# CONSTRUCTION PLANS FOR THE HILLS AT LORSON RANCH FILING NO. 2

## STREET & STORM SEWER CONSTRUCTION PLANS

**THE RIDGE AT LORSON RANCH FIL NO. 2  
STREET & STORM SEWER  
CONSTRUCTION PLANS**

DATE: NOV, 2021  
PROJECT NO. 100.067  
SHEET NUMBER C6.42  
TOTAL SHEETS: 28

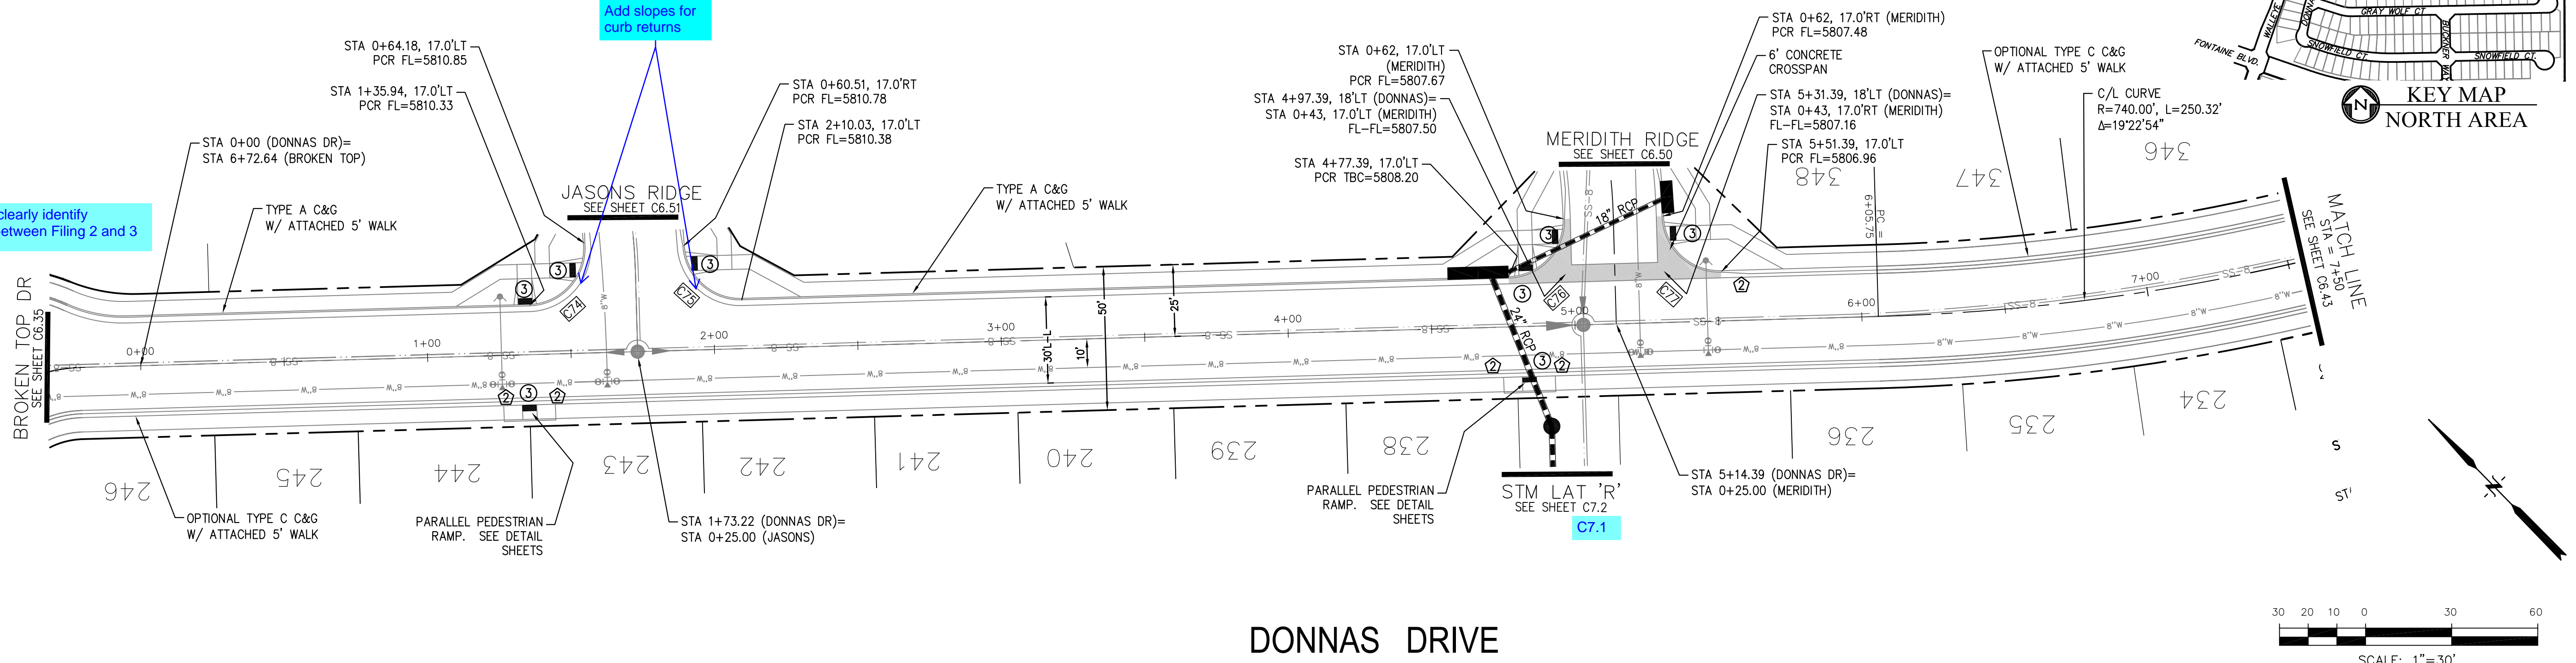
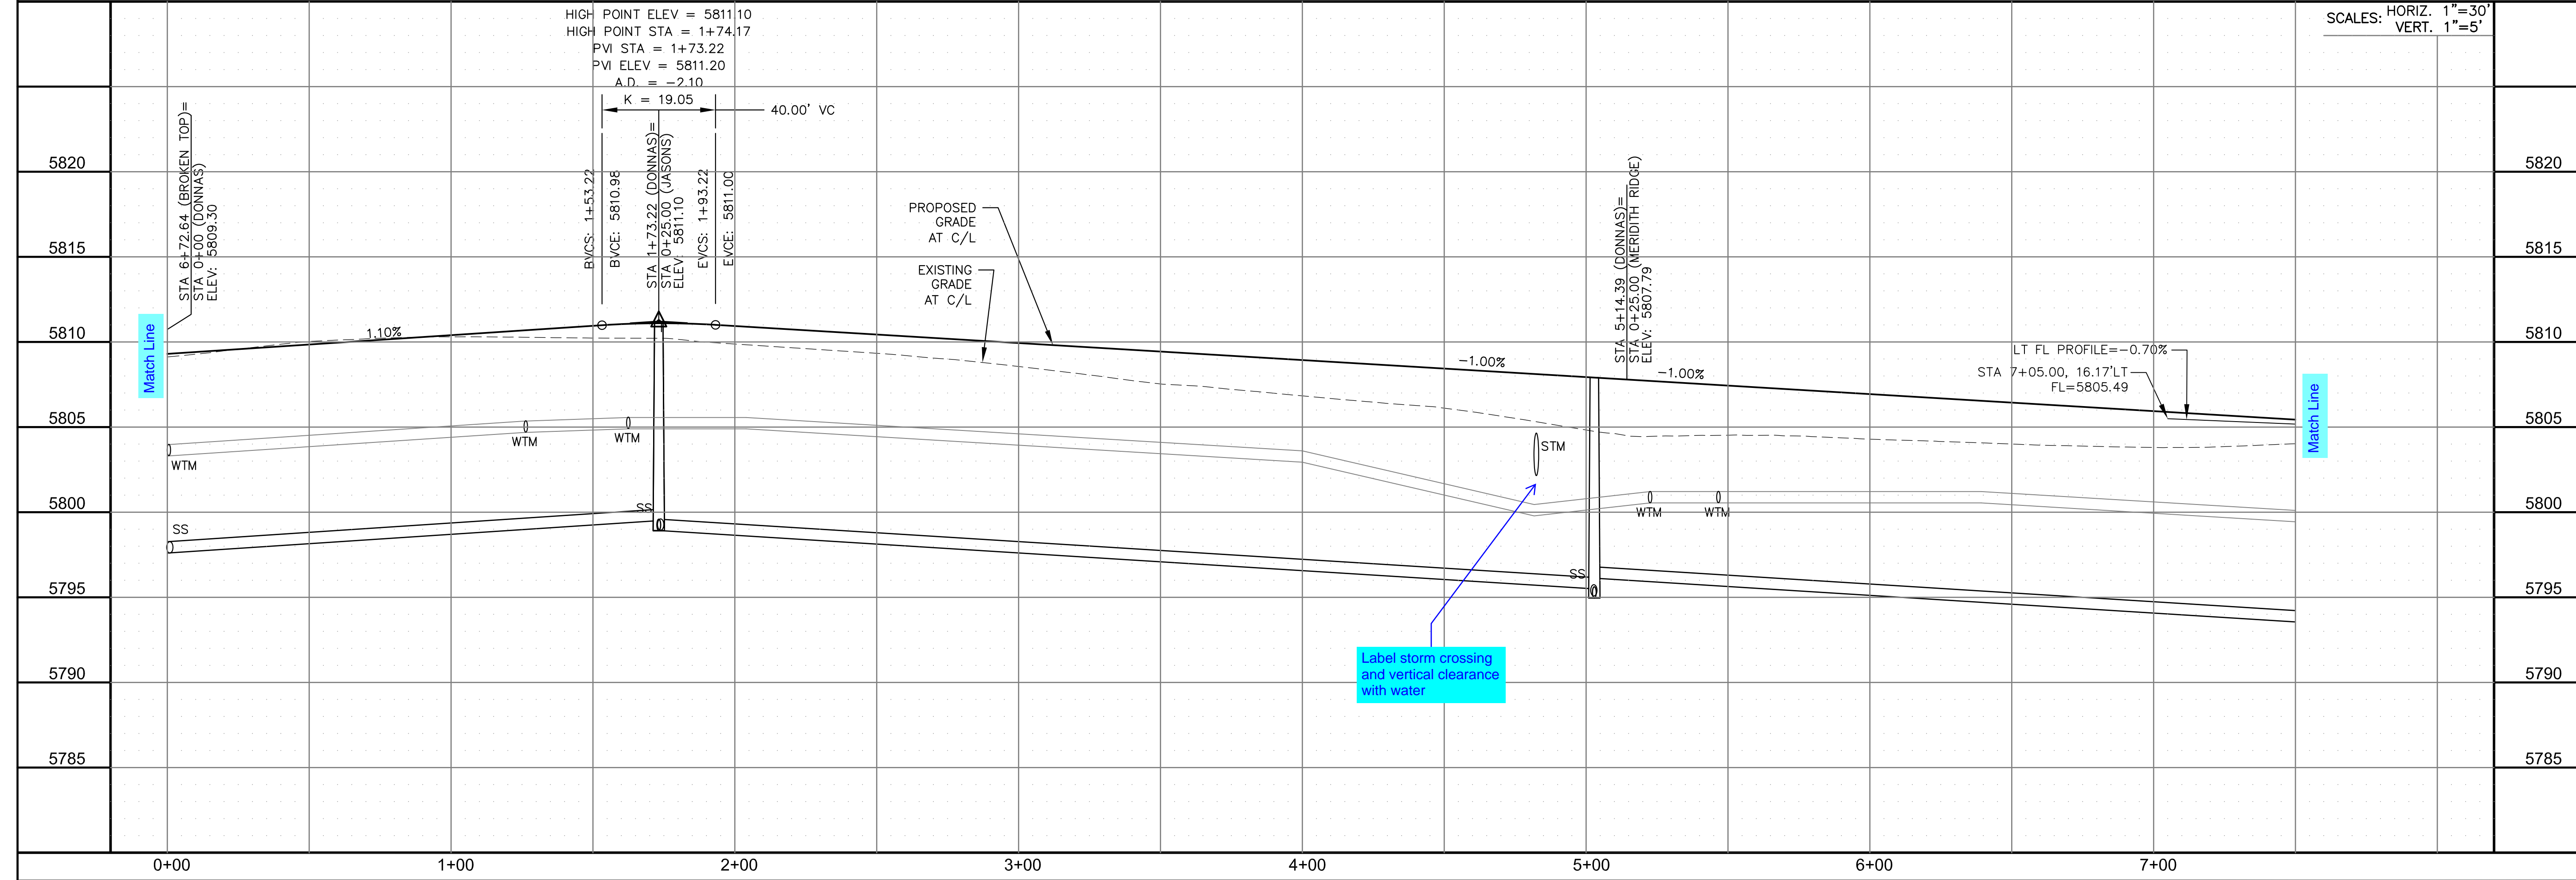
Show and clearly identify boundary between Filing 2 and 3

Add slopes for curb returns

SHEET NUMBER C6.50

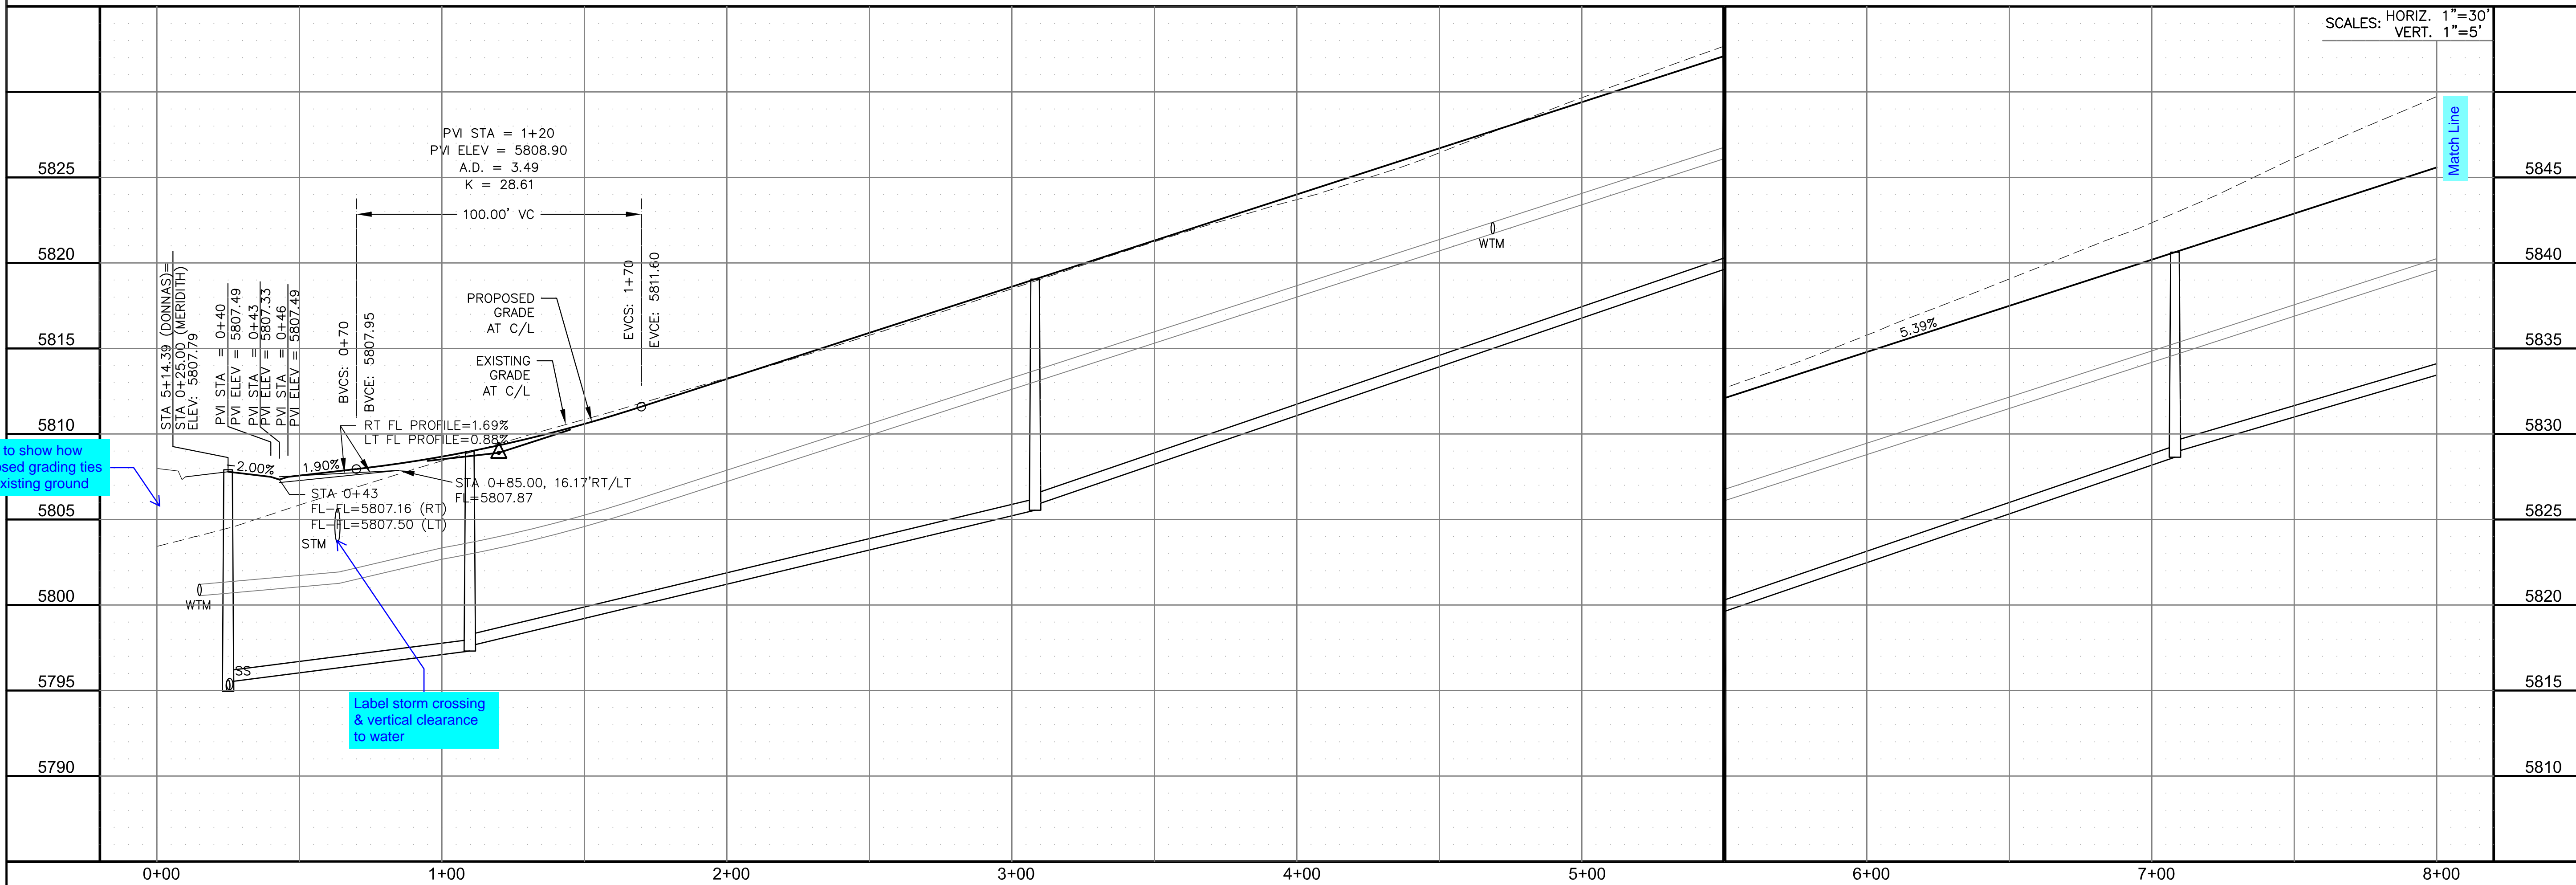
Need to show how proposed grading ties into existing ground

SHEET NUMBER C6.55

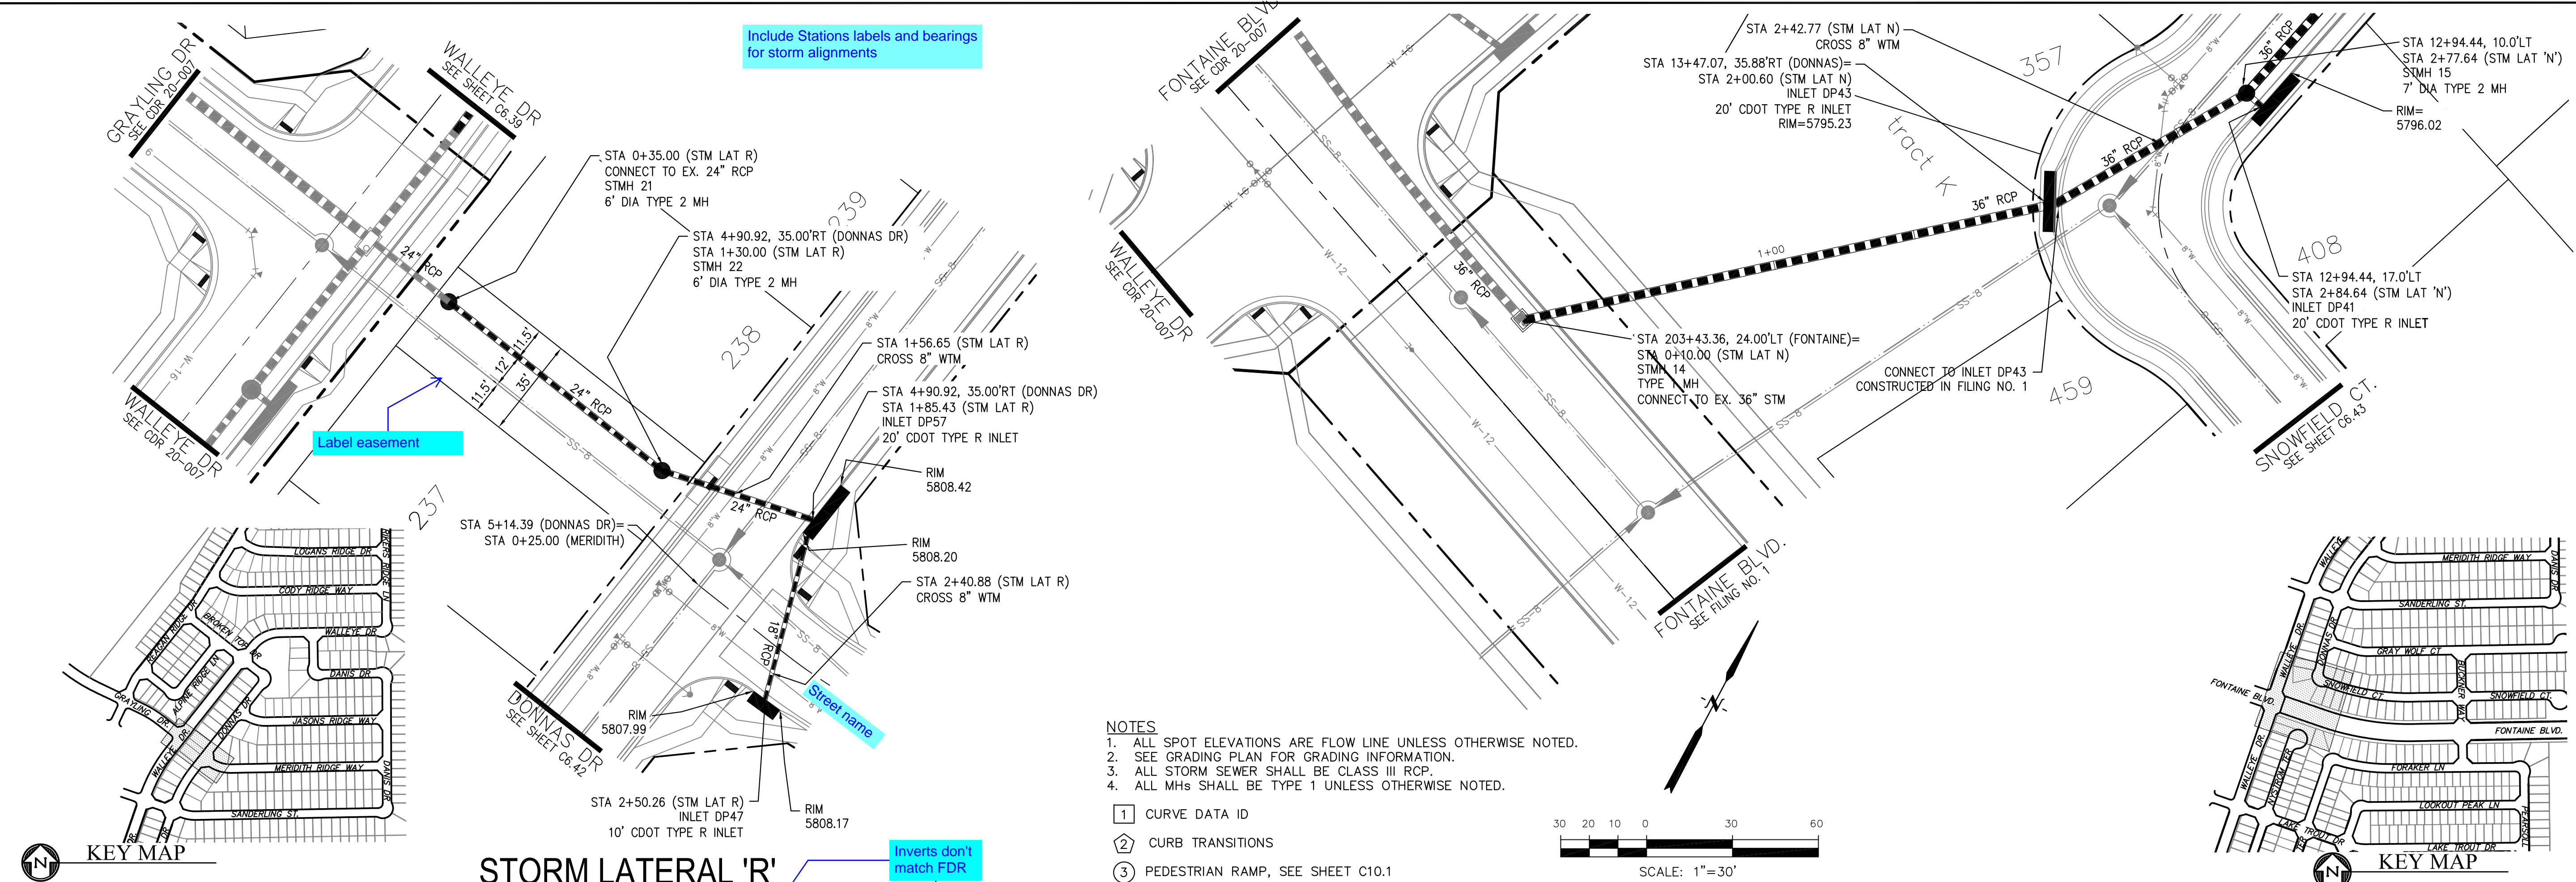
Need to show how proposed grading ties into existing ground
